Amendments to the Drawings:

Annotated Sheet Showing Changes

REMARKS/ARGUMENTS

1/5

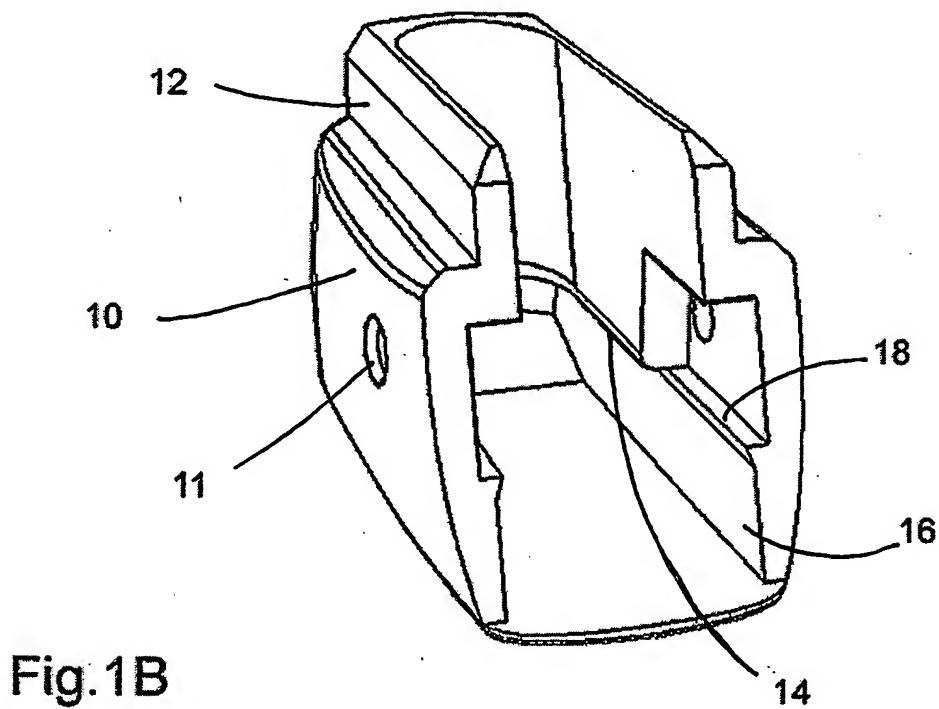
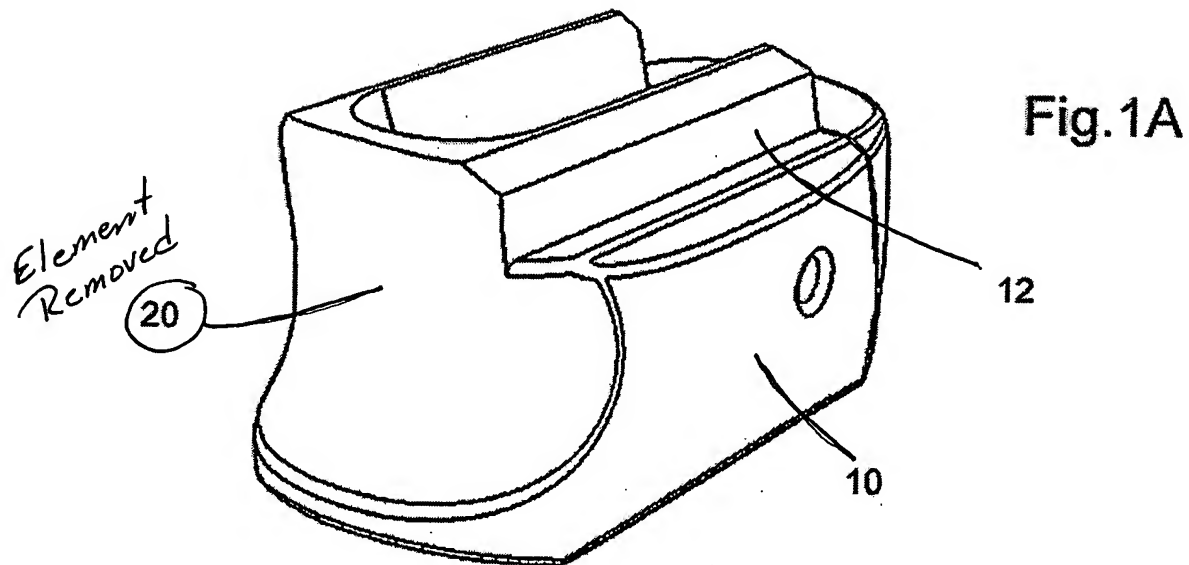
The attached sheet of drawings include changes to Fig.s 1,4 and 5. Fig. 1 has element 20 removed. Fig.s 4 and 5 have now dashed the figures that are pre-existing and not part of the invention.

Fig.4

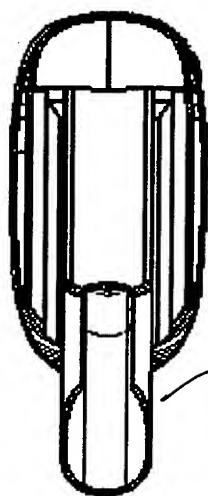
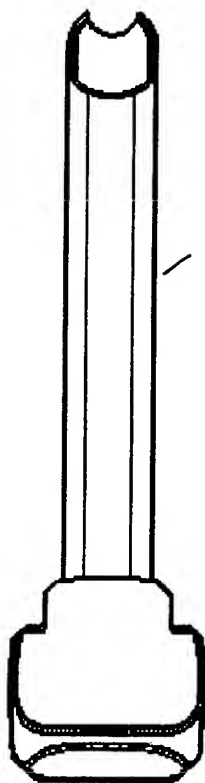
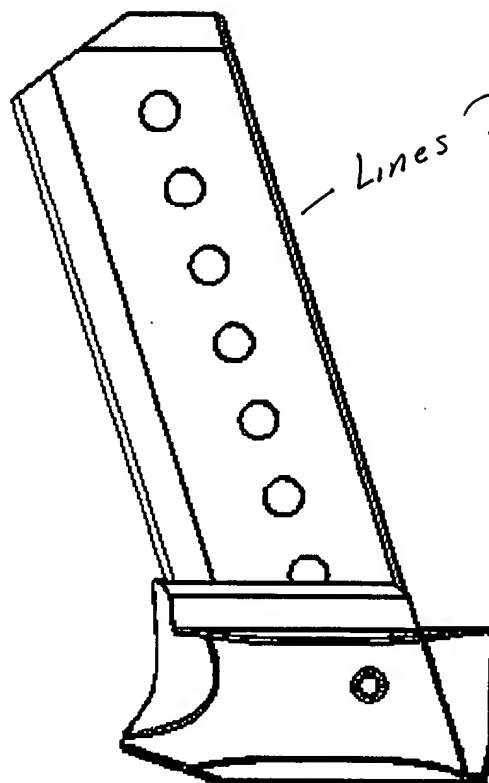
Applicant has more clearly defined the claims to refer to a device attached to an extended length magazine that enables that magazine to more effectively interact with a handgun. Applicant has also modified the drawings to more clearly identify the device from the pre-existing magazine and handgun. The pre-existing magazine and handgun as illustrated are now consistently dashed in the drawings.

LINES
DASHED

LINES
DASHED

Lines DASHED
